KWM-380 TRANSCEIVER (622-5093-101)  
HF-380 TRANSCEIVER (622-3580-101)  
RECEIVER-EXCITER CIRCUIT CARD A3 (638-6908-001)

SERVICE BULLETIN NO 1

PRODUCT IMPROVEMENT

P/O Receiver-Exciter Assembly A3,  
Schematic Diagram  
Figure 3

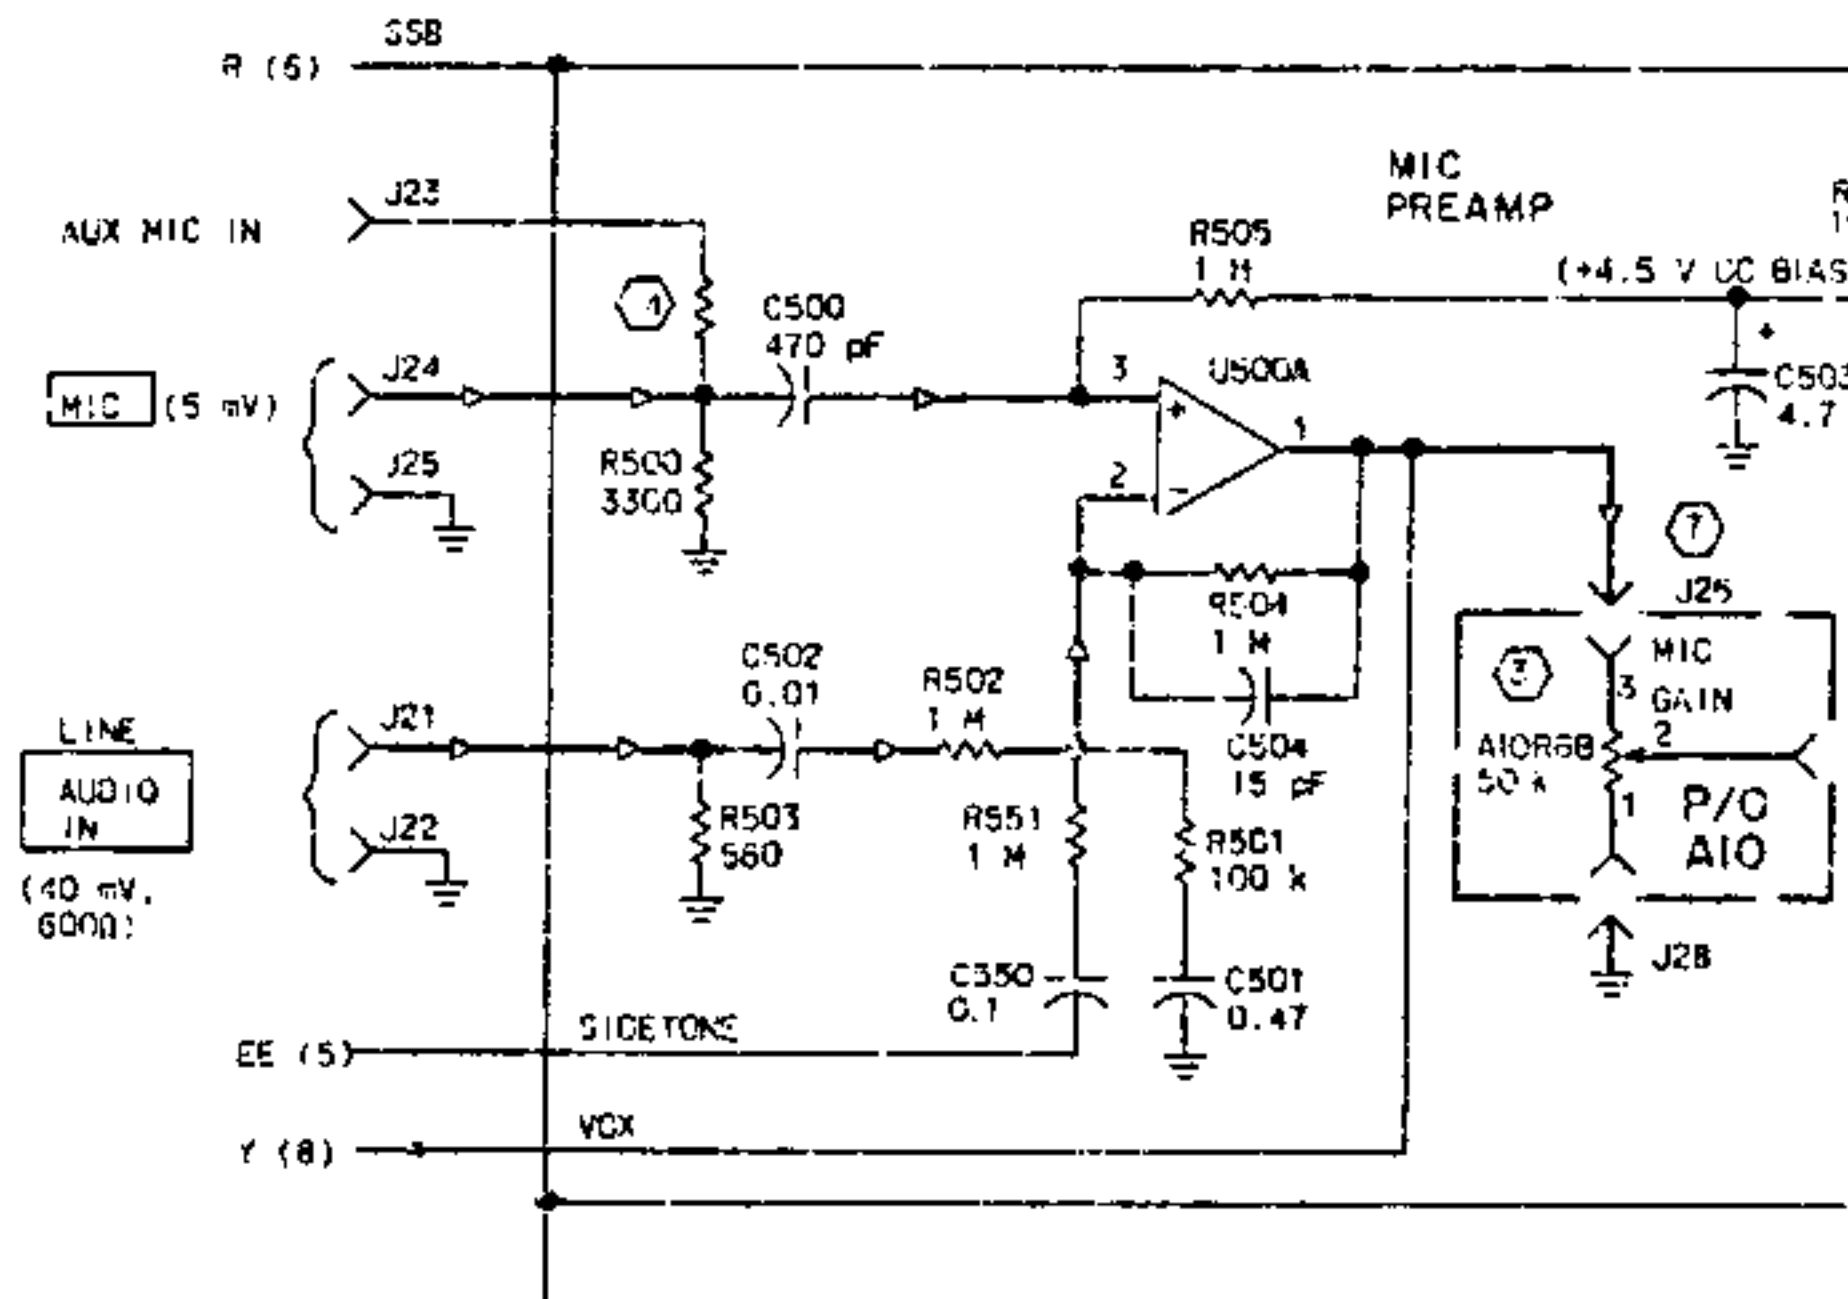
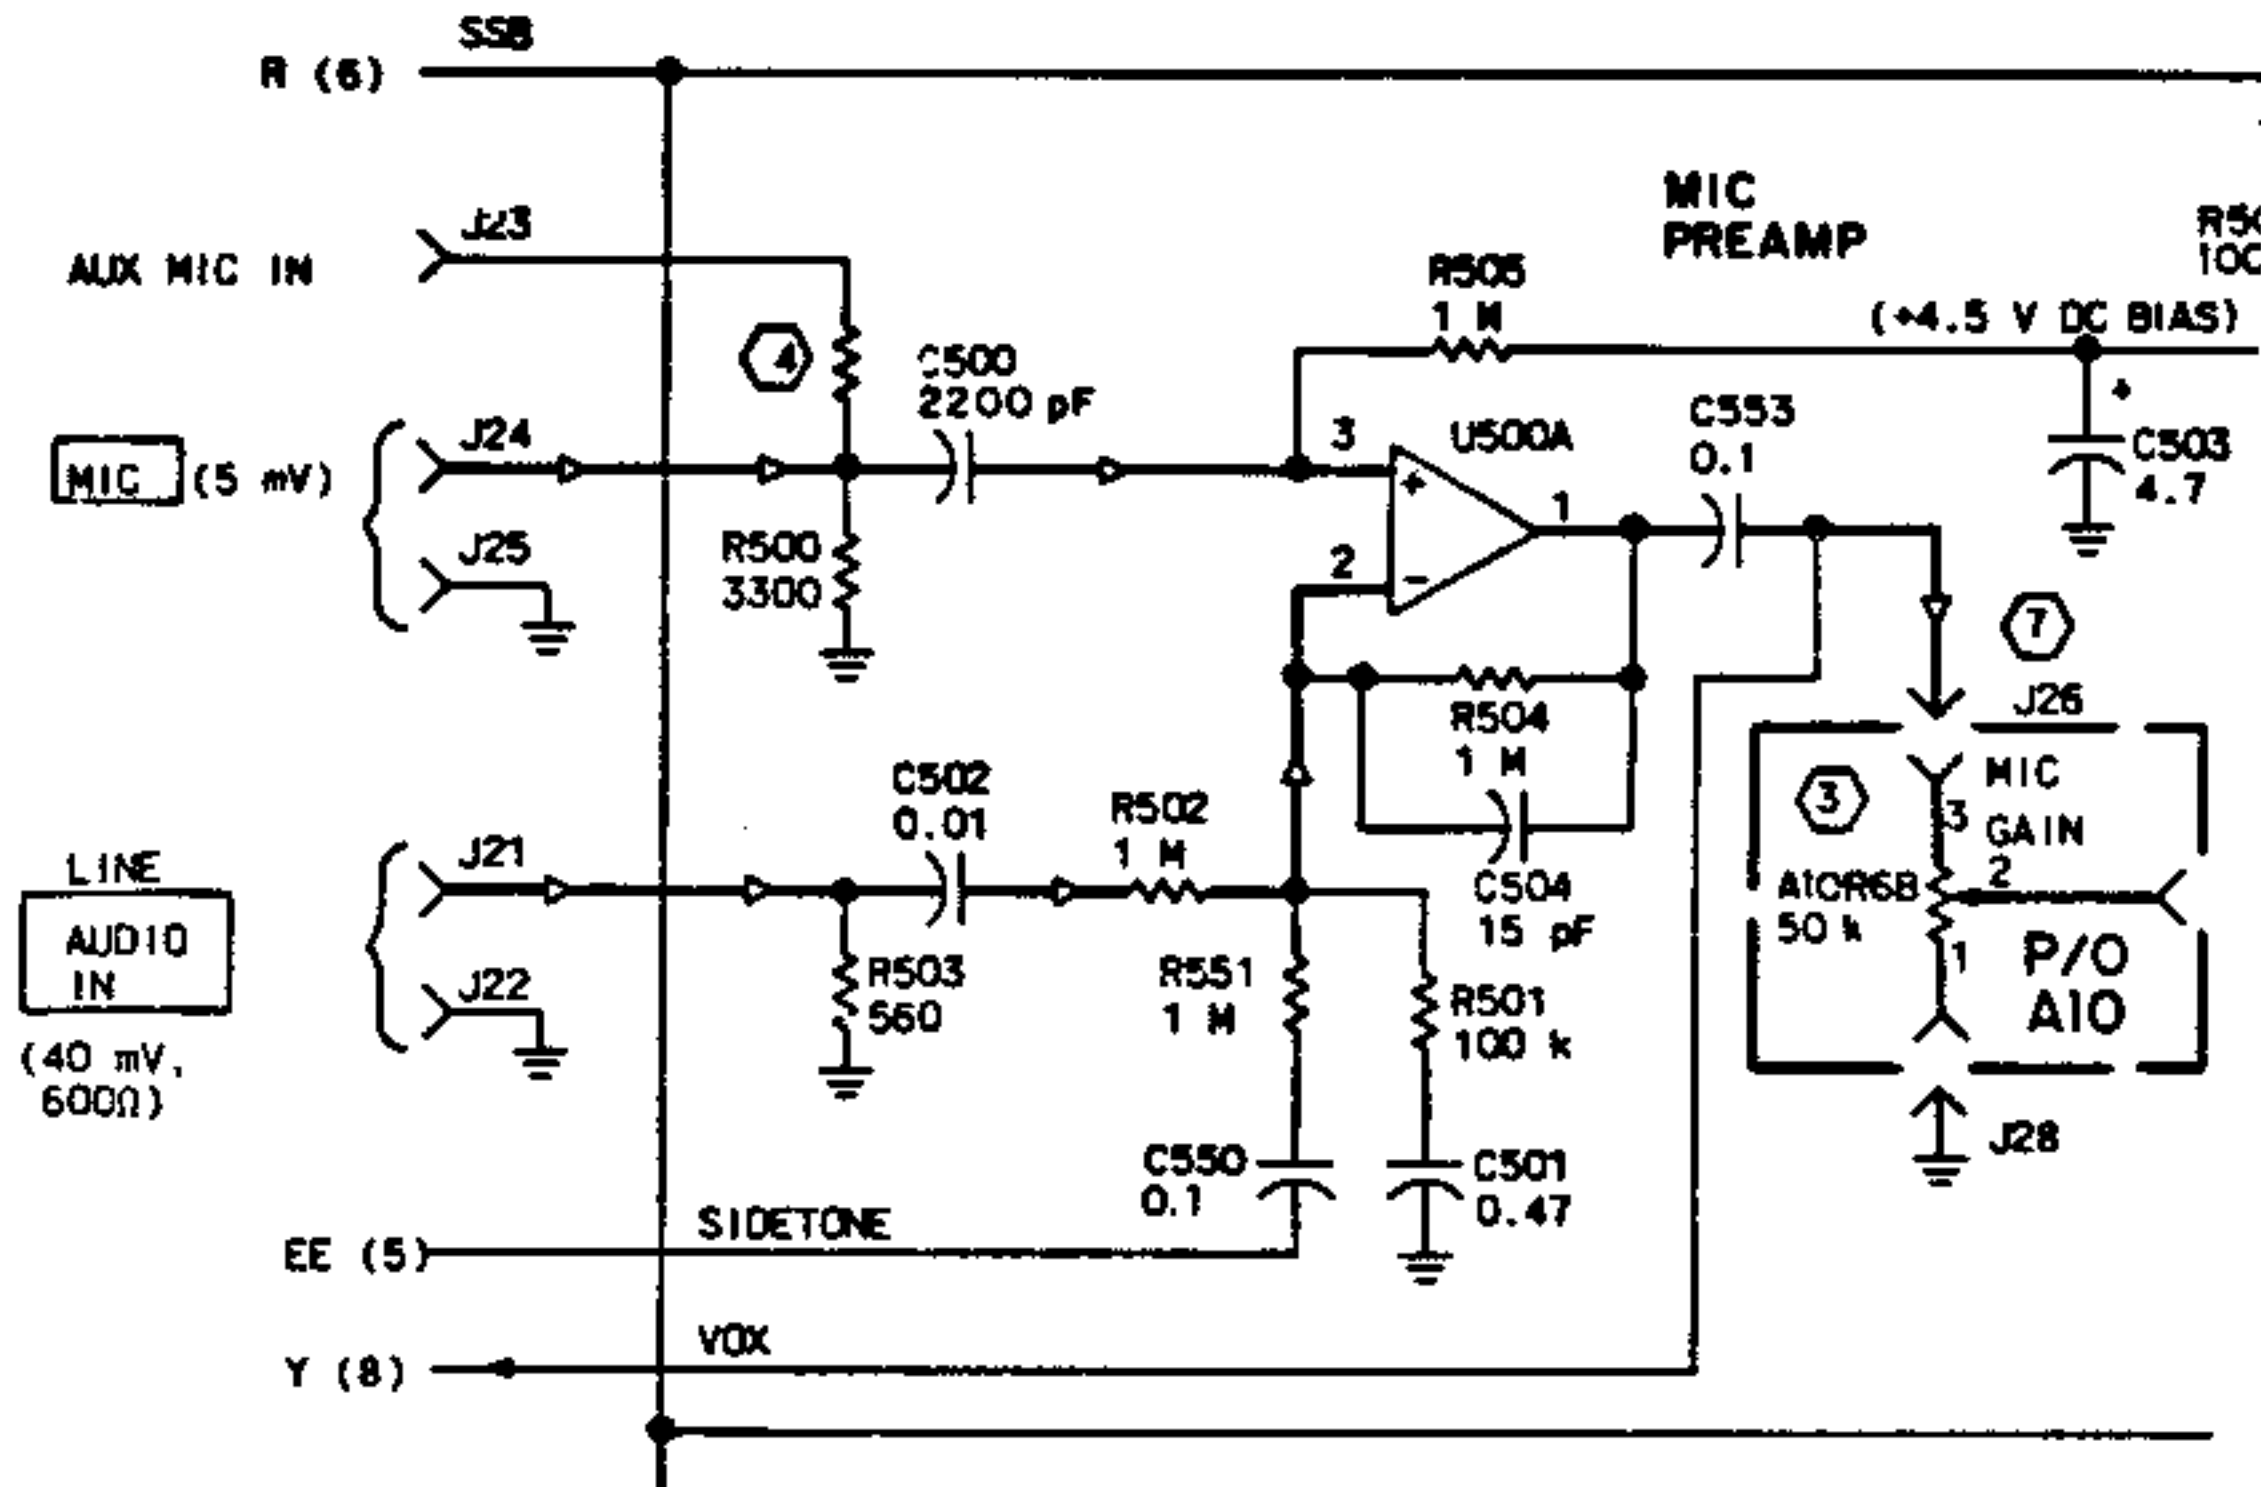
NOTE: Refer to figure 2 while performing steps F through H. Capacitor C553 is part of receiver-exciter assembly A3 but is mounted on front panel assembly A10. If C553 were mounted on the A3 card, a circuit trace cut on the bottom of the card would be required making it necessary to remove the card from the radio. Refer to figure 3 for a schematic diagram which shows the location of C553.

Directional Coupler/TR Relay A2A2  
Figure 1

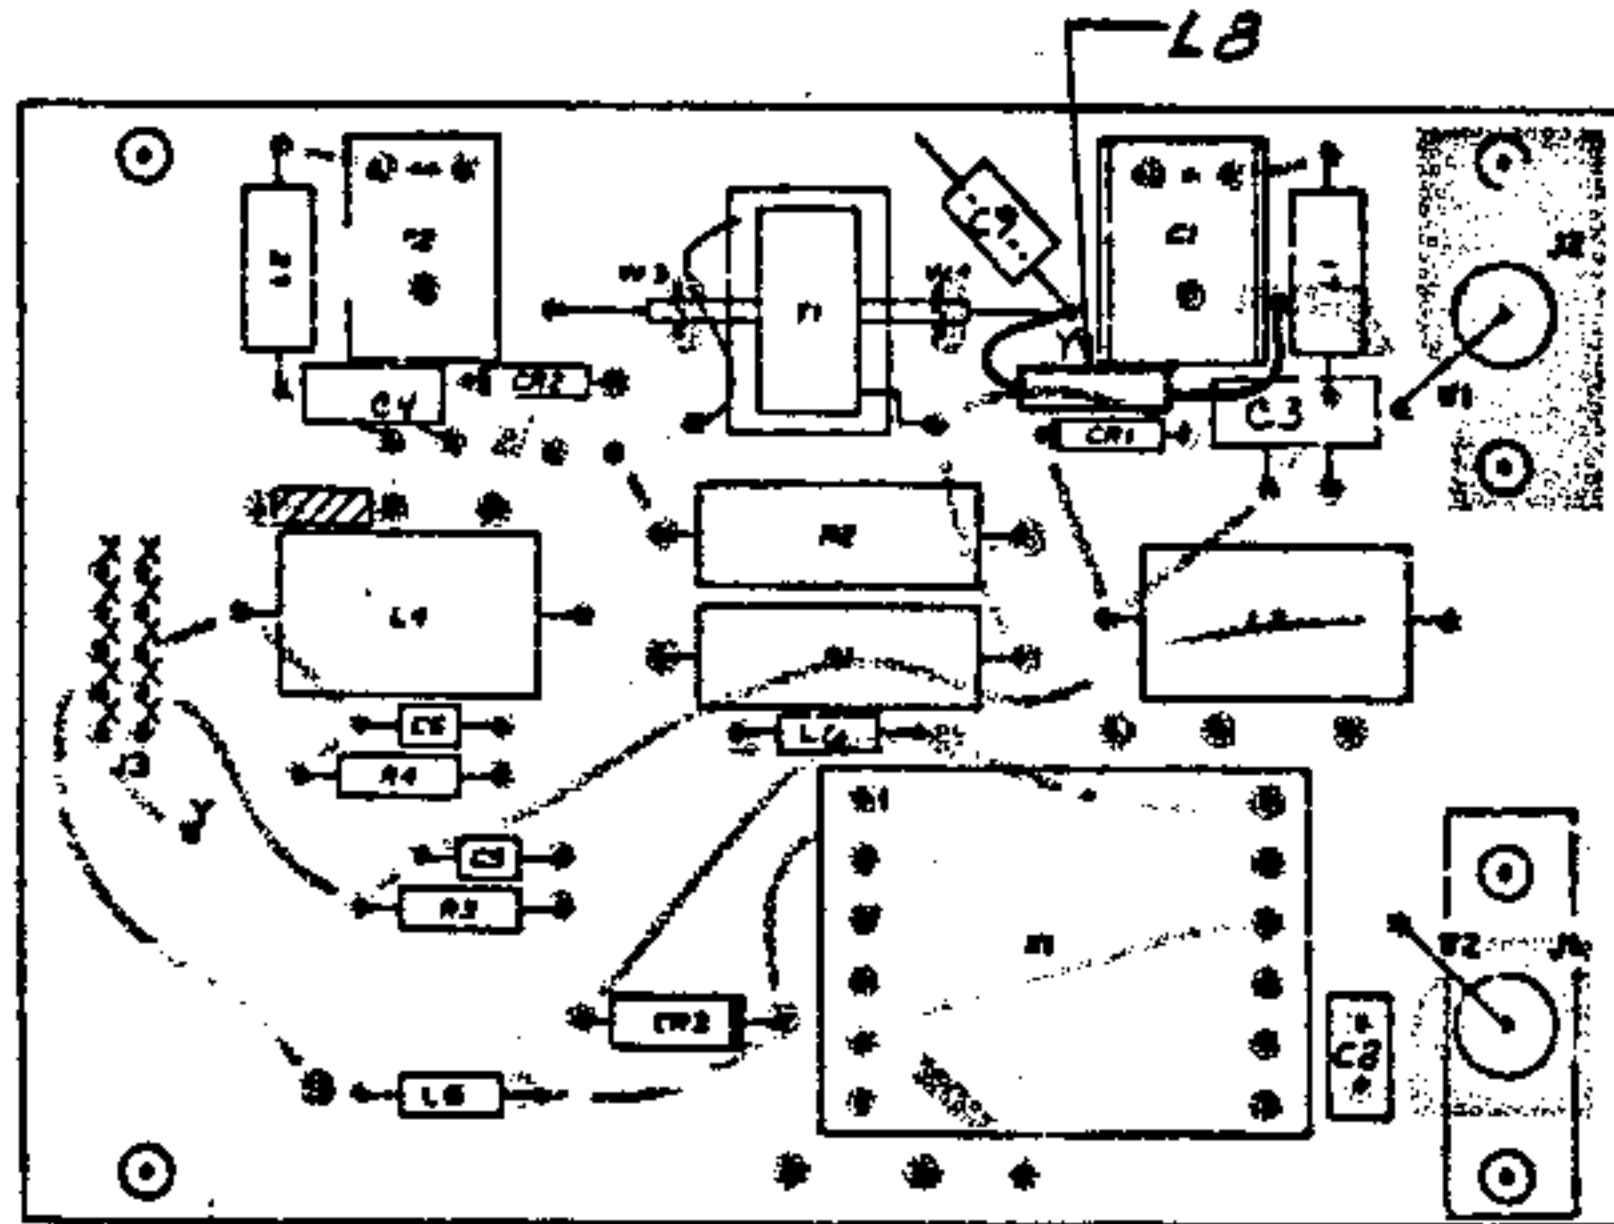
- F. Refer to figure 1. Install 220- $\mu$ H choke L8 (240-2524-000) as follows:
